Delegated Report		Analysis sheet	Expiry Date:	14.6.17 (extended by agreement to 4.6.18)
		N/A	Consultation Expiry Date:	25.5.17
Officer		Application Number(s)		
Charles Thuaire		2017/2064/P, 2017/2211/L		
Application Address		Drawing Numbers		
Land Adjacent to Jack Straws Castle North End Way London NW3 7ES		See decision notice		
PO 3/4	Area Team Signature	C&UD	Authorised Officer Signature	
Proposal(s)				
2017/2064/P- Erection of two x 4 bedroom 3 storey plus basement residential dwelling houses on rear part of carpark, and associated landscaping, refuse and cycle stores and reconfigured carparking on remainder of carpark.				
2017/2211/L- Erection of two dwelling houses on rear part of carpark plus associated underpinning of adjacent basement of existing listed building of Jack Straws Castle.				
Recommendation(s):	Had appeals not been lodged against non-determination, the Council would have refused planning permission and listed building consent

Application Type:	Full Planning Permission and listed building consent

1.1 Erection of two 4 bedroom dwellinghouses on existing car park adjacent to Jack Straws Castle, including associated redesign and landscaping of remaining car par

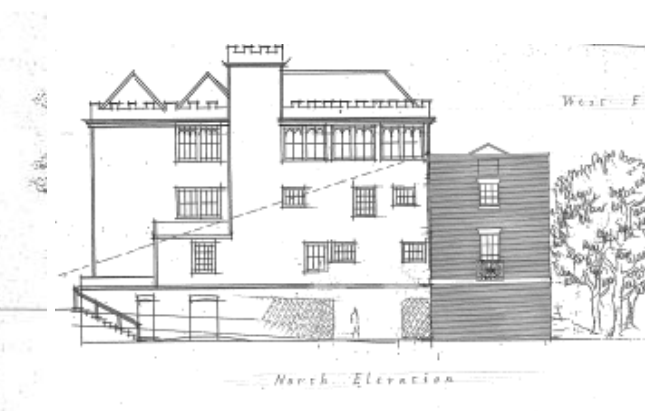
4.10 In comparison, the current proposal for a taller and wider development, 3 storeys high across the whole carpark's back edge, is clearly larger than the previous 2004 scheme. This is demonstrated by the comparison extracts of front and side elevations of both previous and current schemes shown here:

4.11 On the face of it and in light of these appeal decisions, the current proposal would have a greater unacceptable impact in enclosing the open space of the carpark. Thus it could be argued that the currently proposed houses, and indeed any structure larger than a single storey garage, would continue to erode the distinctive quality of the carpark in its role as an open area of curtilage around the main castellated block, as discussed in para 4.8 above.

4.12 However officers also acknowledge that there are 3 subtle but important differences between the past and current schemes that help sway the balance. As demonstrated in the comparison images above, the latest 2004 appeal scheme projected beyond the junction between the rendered rear

section of the building and the main weather-boarded façade, it was designed as an extension in matching pastiche design, and the carpark had a solid boundary around part of it. In contrast the new scheme is set back further and respects the junction between both elements of the main building, it is conceived as a distinctive separate building with contrasting design idiom, and the carpark is left largely open as existing. These are considered to be positive moves in design terms.
